Memorandum

RE: MMU Comments on 2020 Reliability Needs Assessment

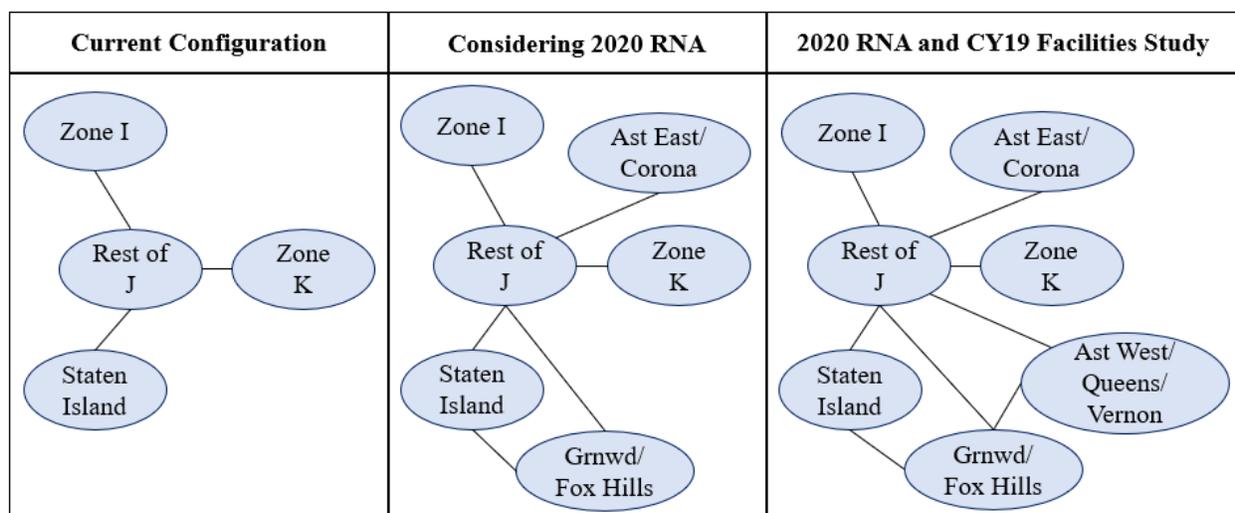
Currently, the GE MARS topology represents transmission limitations between Staten Island and the rest of NYC. However, the topology could be modified to represent the transmission constraints resulting in transmission security violations in the 2020 RNA and the Class Year 2019 Facilities Study. These alternatives are illustrated in the following figure, which shows: (a) the current configuration represented in GE MARS topology, (b) a possible configuration implied by the transmission security violations in the 2020 RNA, and (c) a possible configuration if the Class Year 2019 Facilities Study is also considered.

Enhancing the GE MARS topology to reflect transmission limitations among areas within New York City would allow for the resource adequacy analysis to model the differences in the value of resources in different areas of New York City. If these enhancements were implemented along with C-LMP, capacity prices would rise in import-constrained load pockets such as the Greenwood/Fox Hills 138 kV TLA, which would likely reduce or eliminate the need for out-of-market investment there. Furthermore, these enhancements would cause capacity prices to fall in export-constrained areas such as Staten Island and the “Rest of J” where new entry is currently limited by transmission upgrade costs in the interconnection process.

We have recommended that NYISO adopt a locational marginal price of capacity (“C-LMP”) framework in our 2019 State of the Market report (see Recommendation #2013-1c).⁹ Under this approach, the NYISO would set capacity clearing prices at multiple locations based on the marginal benefit to system reliability for resources at those locations. C-LMP would provide flexibility to model key constraints identified by transmission security analysis within the resource adequacy framework, resulting in differentiated price signals for resources upstream and downstream of those constraints. In the resource adequacy analysis, transmission constraints are represented by the GE MARS topology, and C-LMP would set a clearing price for each location represented in the topology.
